A RESOLUTION AUTHORIZING CHANGE ORDER NO. 2 TO THE CONTRACT BETWEEN THE CITY OF LAS CRUCES AND WARREN CONSTRUCTION, INC., FOR THE THOMAS BRANIGAN MEMORIAL LIBRARY CHILDREN'S WING RENOVATIONS, AS APPROVED BY CITY COUNCIL UNDER RESOLUTION NO. 08-09-467, AUTHORIZING AN INCREASE IN THE AMOUNT OF \$98,332.47; PLUS NEW MEXICO GROSS RECEIPTS TAX OF \$11,032.23; PLUS PROJECT CONTINGENCY OF \$50,000.00; FOR A TOTAL AUTHORIZATION OF \$159,364.70.

CHANGE ORDER

PROJECT:	Branigan Library Children's Wing Renovation	CHANGE ORDER NUMBER:	Two (2)
		DATE:	July 24, 2009
TO CONTRACTOR:	Warren Construction, Inc. PO Drawer N Mesilla, New Mexico 88046	ARCHITECT'S PROJECT NO.:	05.23
		CONTRACT DATE:	February 19, 2009
		CONTRACT FOR:	General Construction

PROJECT: Branigan Library Children's Wing PROPOSAL REQUEST NUMBER: ~~Two (2)~~ 5
 200 E. Picacho Ave.
 Las Cruces, NM 88001 DATE: July 6, 2009

REVISED FLOOR PLAN - CHILDREN'S AREA
 1/8" = 1'-0"

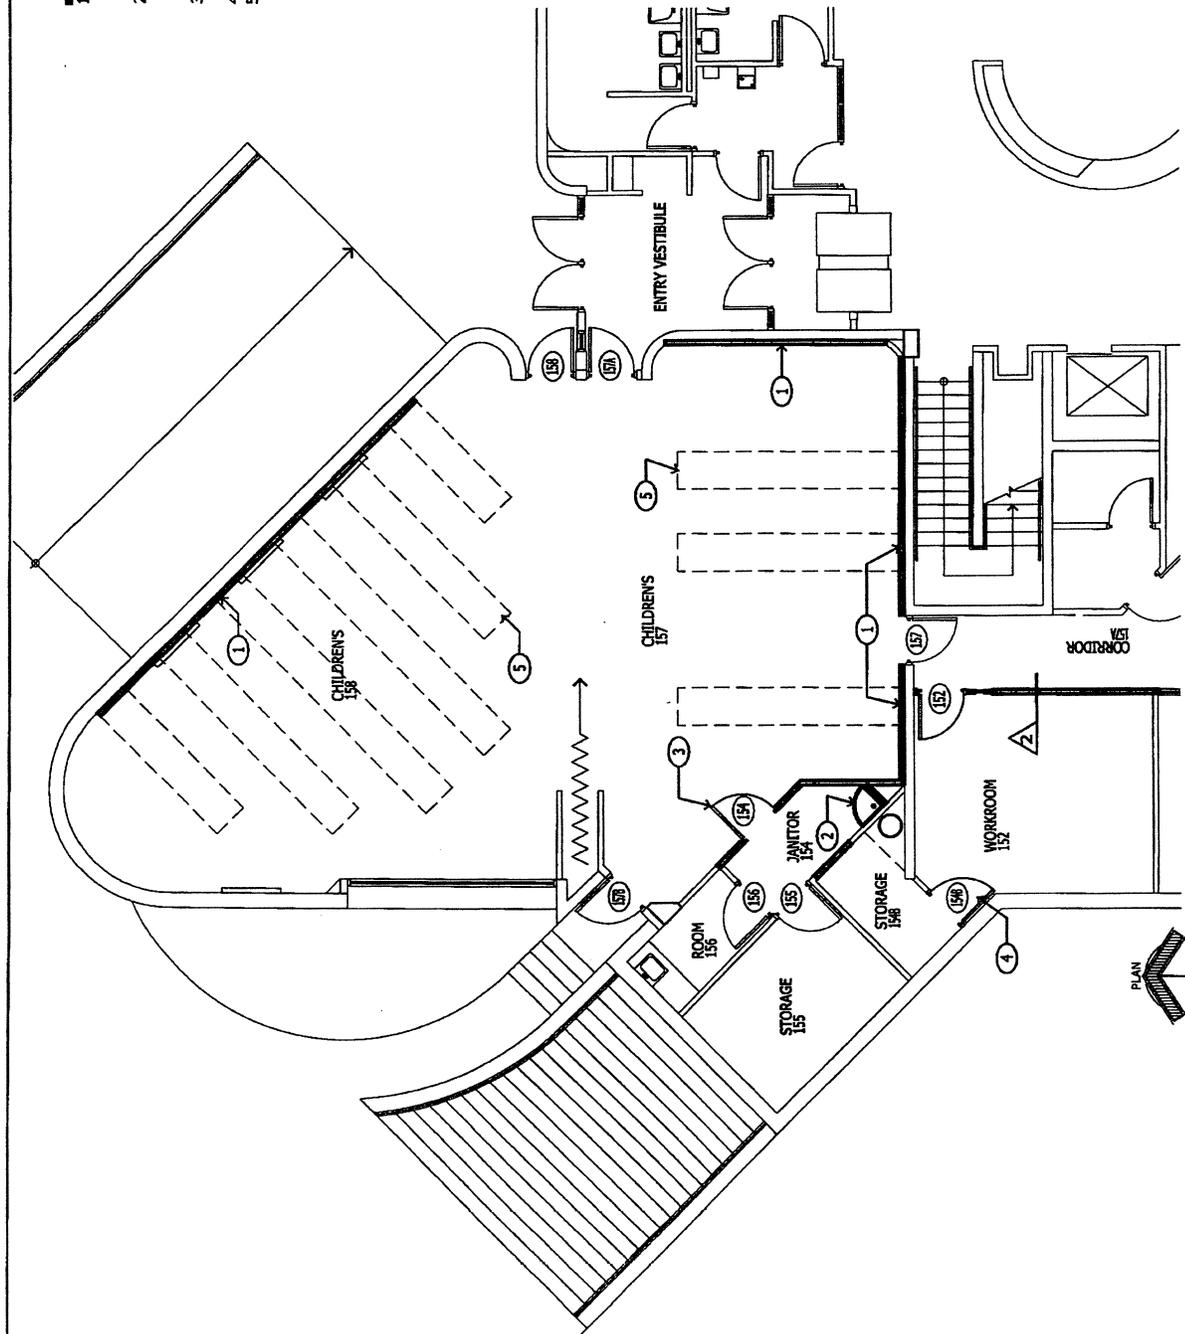
1. Provide new furrount walls in Children's 157 & 158 to extents shown on supplemental drawings sheets and as required for the installation of new electrical and data for computers to be provided by owner.
2. Provide additional electrical and data in Children's 157 & 158 per electrical/arch.
3. Provide additional work required for installation of new split system in storage 155 per mep.
4. Address roof leaks in Children's 157 & 158, storage 157, and room 156 (contractor to field verify existing conditions and provide proposal amount for the required measures to repair these areas and make them water tight).
5. Address leaks on stair well located on the southwest side of the library (contractor to field verify existing conditions and provide proposal amount for the required measures to repair these areas and make them water tight).

- KEYED NOTES**
1. ELECTRICAL FURROUT WALL - 3-5/8" MTL. STUDS @ 16" O.C. FASTENED TO EXISTING WALL, PROVIDE 5/8" GYP. BD. AT OUTER FACE, TAPE, TEXTURE, AND PAINT.
 2. MOP SINK LOCATION TO BE MODIFIED TO AREA SHOWN, MODIFY PLUMBING AND VENTING AS REQUIRED AND CONNECT AS SHOWN ON ORIGINAL PLUMBING DRAWINGS.
 3. DOOR AND FRAME LOCATION TO BE MODIFIED TO AREA SHOWN.
 4. PROVIDE NEW DOOR AND FRAME TO MATCH DOOR 154.
 5. HIDDEN LINE OF FURNITURE TO BE PROVIDED/INSTALLED BY OWNER. SEE ELECTRICAL SUPPLEMENTAL SHEETS FOR EXTENTS OF ELECTRICAL WORK TO BE PERFORMED FOR EXTRA POWER AND DATA IN THESE AREAS.

REVISED MECHANICAL FLOOR PLAN
 SCALE: 1/8" = 1'-0"
 CHILDRENS AREA 1

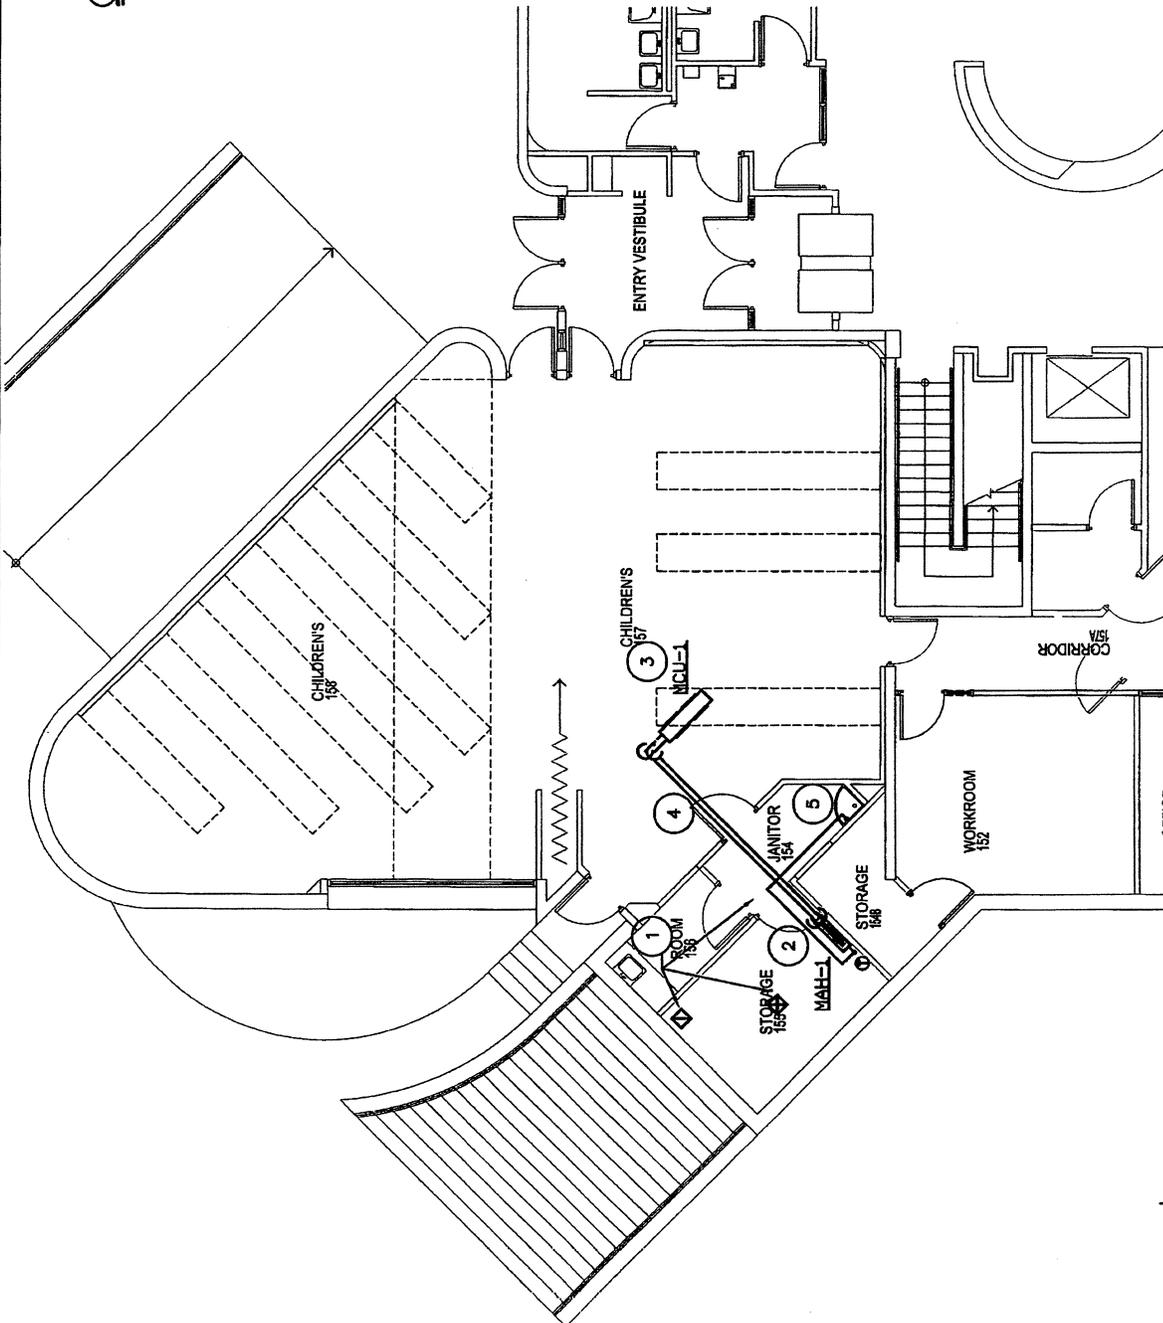
1. REMOVE EXISTING DUCTWORK AND GRILLES FEEDING THE SERVER ROOM. REMOVE DUCT BACK TO NEXT FUNCTIONING OUTLET AND CAP. REMOVE GRILLES AND CAP OPENINGS.

2. INSTALL MAH-1 IN ACCORDANCE WITH MANUFACTURER'S INSTRUCTIONS AND SEE DETAIL. COORDINATE WITH DOOR, EXISTING CONDUIT, AND OTHER EQUIPMENT IN THE ROOM. COORDINATE ALTERNATE LOCATION WITH ARCHITECT IF UNIT WILL NOT FIT CORRECTLY IN THIS LOCATION.

3. INSTALL MCU-1 ON ROOF ABOVE. INSTALL IN ACCORDANCE WITH MANUFACTURER'S INSTRUCTIONS AND SEE DETAIL. COORDINATE LOCATION WITH ROOF ELEMENTS AND OTHER ROOF EQUIPMENT.

4. EXTEND REFRIGERANT PIPING AND CONTROL AND POWER WIRING IN CEILING SPACE AND PENETRATE ROOF AT THE LOCATION OF MCU-1. PROVIDE REFRIGERATION GRADE INSULATION ON REFRIGERANT PIPING.

5. CONNECT MAH-1 CONDENSATE PUMP PIPING TO 1/2" PVC PIPING IN CEILING SPACE AND EXTEND AROUND TO NEW MOP SINK AS INDICATED. ROUTE PIPING DOWN WALL AND LEAVE 1" AIR GAP ABOVE FLOOD RIM OF MOP SINK. DRAIN PIPING TO BE INSULATED WITH 1/2" FOAM INSULATION.

REVISED ELECTRICAL PLAN - CHILDREN'S AREA 1
 1/8" = 1'-0"

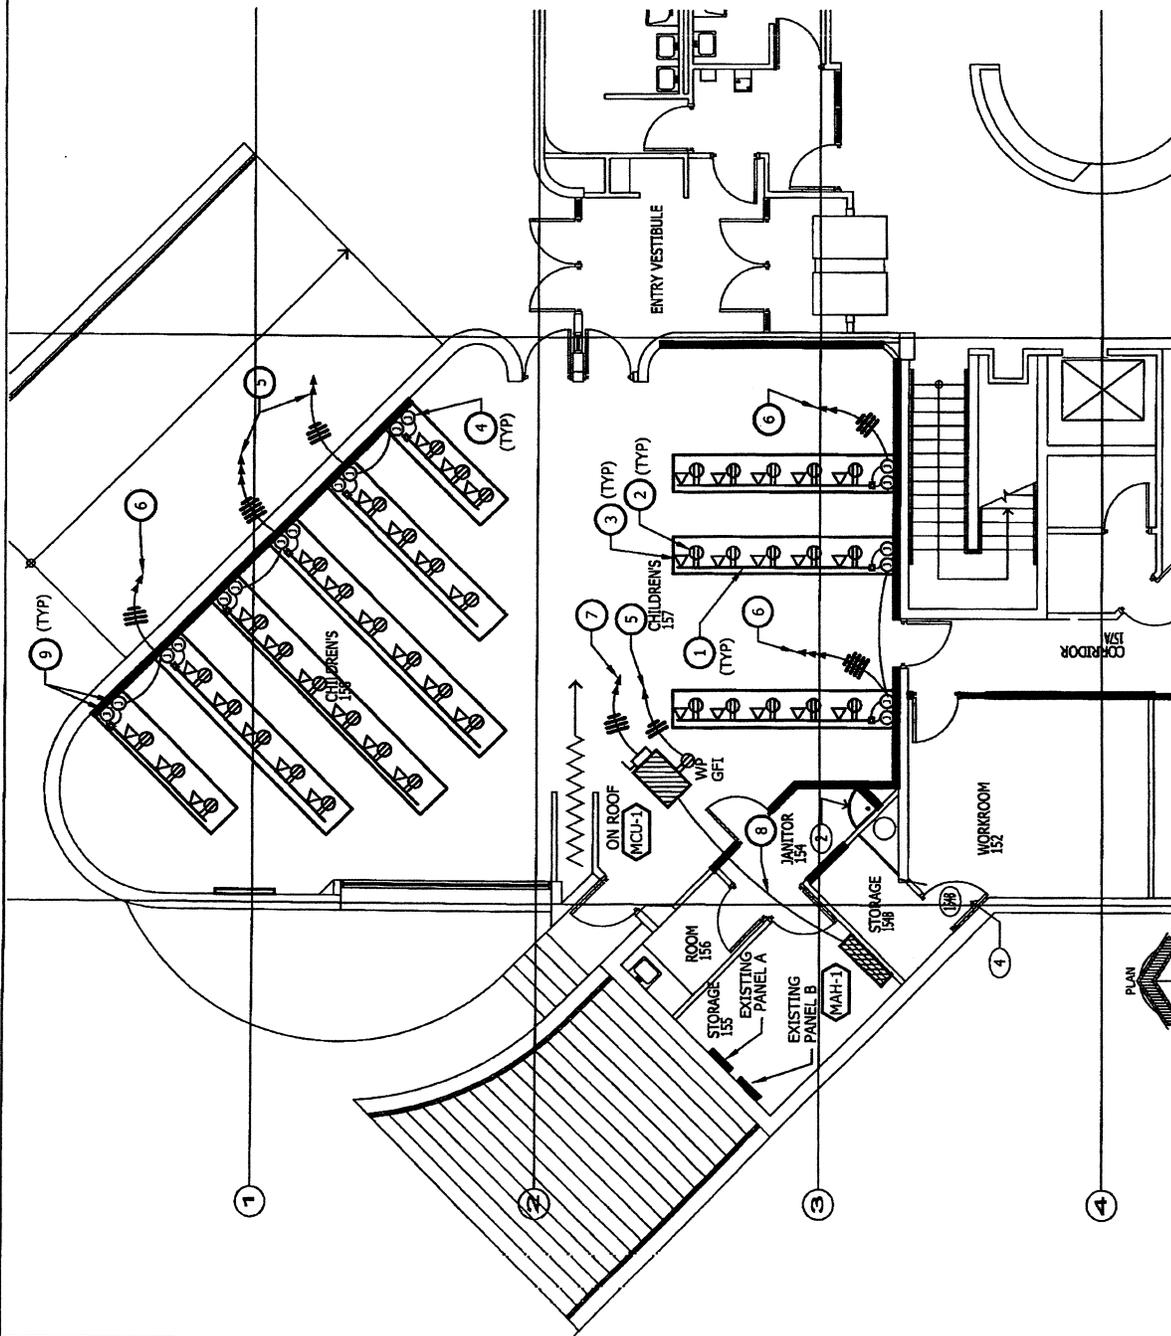
- 1 (2) CHANNEL ALUMINUM RACEWAY SUCH AS WIREMOLD 4000 SERIES OR APPROVED EQUAL. PROVIDE BACK SUPPORT ON TABLES AS APPLICABLE FOR RACEWAY INSTALLATION. DISTRIBUTE OUTLETS AMONG INDICATED CIRCUITS SUCH AS A MAXIMUM OF (4) COMPUTER STATIONS ARE CONNECTED PER CIRCUIT.

- 2 DUPLEX OUTLET INTEGRAL WITH RACEWAY SYSTEM. FIELD COORDINATE LOCATION WITH COMPUTER STATION.
- 3 SINGLE DATA OUTLET INTEGRAL WITH RACEWAY SYSTEM. FIELD COORDINATE LOCATION WITH COMPUTER STATION.

- 4 FROM J-BOX. STUB UP A 1" WITH PULL STRING UP TO CEILING SPACE FOR DATA COMMUNICATION CABLES.
- 5 CONNECT TO AVAILABLE SPACE ON PANEL C. PROVIDE 1X20A BREAKERS TO MATCH EXISTING RATINGS AND UPDATE PANEL DIRECTORY.

- 6 CONNECT TO AVAILABLE SPACE ON PANEL A. PROVIDE 1X20A BREAKERS TO MATCH EXISTING RATINGS AND UPDATE PANEL DIRECTORY.
- 7 CONNECT TO AVAILABLE SPACE ON PANEL A. PROVIDE A 2X20A BREAKER TO MATCH EXISTING RATINGS. AT UNIT, PROVIDE A 250V, 1PH, 30A, GD, 3R DISCONNECT SW. UPDATE PANEL DIRECTORY.

- 8 FOLLOW MANUFACTURER INSTALLATION GUIDELINES FOR INTERCONNECTION OF INDOOR AND OUTDOOR UNITS.
- 9 FLUSH MOUNTED 4X4" JBOXES FOR POWER AND DATA CONNECTION TO RACEWAY SYSTEM.

- 10 FLEXIBLE 3/4" C OR 1" C AS APPLICABLE TO CONNECT J BOX TO CORRESPONDING CHANNEL IN WIREMOLD.
